REVIEW COMMENTS

FILE #SPR-96-182

TITLE HEADING: Badini Auto Sales Expansion

LOCATION: 901 N 1st Street

SITE PLAN 1"=20'-0"

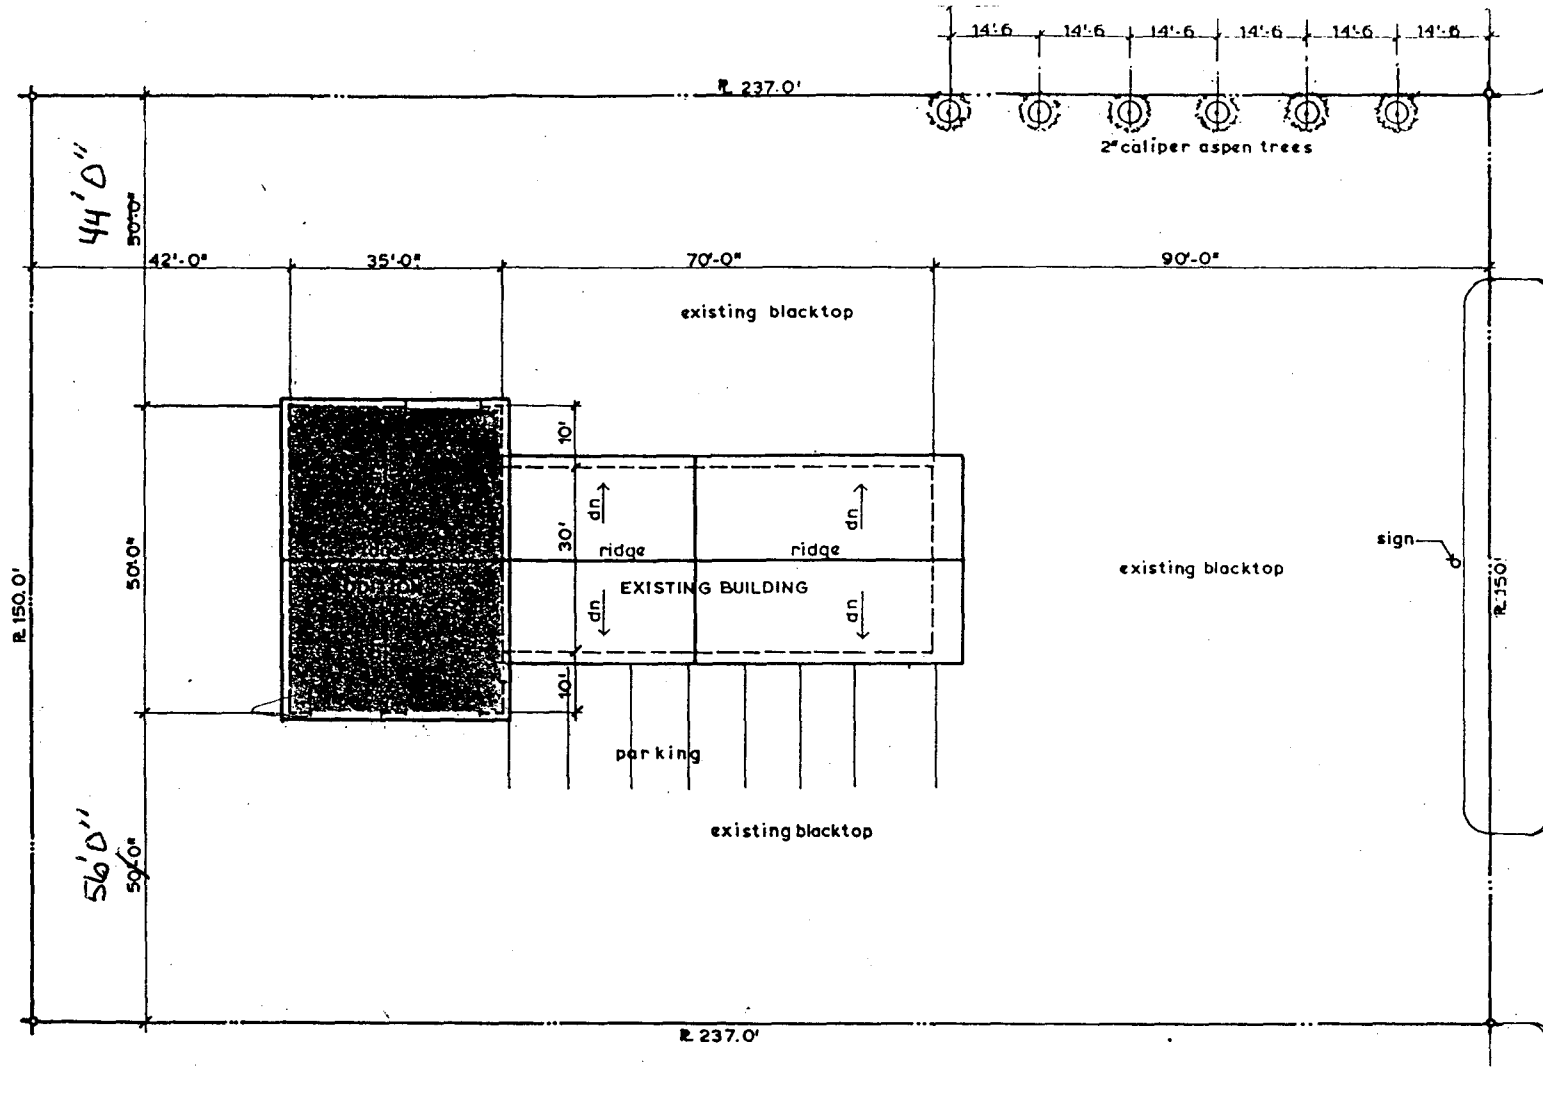
1. Is this an addition to Knowlton or Badini? The Badini address is 901 but the building depicted as existing more closely resembles the building at Knowlton at 931 N. 1st Street.

2. The agreement included in the submittal is no longer valid since the proposal has changed.
3. North 1st Street is classified as a minor arterial and needs 40' of half street right-of-way; therefore, an additional 10 feet of right-of-way must be dedicated.

4. Is the sidewalk shown on the plan proposed to be constructed?
5. The landscaping requirement is based on the street frontage of $150' \times 5' \times .75 = 562.5$ sf. Of the required square footage, 2 trees are required and a minimum of 40% of the landscaped area must be in shrubs. The landscaped area must have an underground, pressurized irrigation system. A detailed landscape plan is required.

6. The site plan must indicate the display area and the customer parking area. The required parking area must be 10% of the gross display area.
7. Show location of existing signage on the site plan.

1. It appears an additional 10' of right of way on 1st Street is required.
2. Sidewalk construction along the frontage is required. A plan for the sidewalk construction is required.
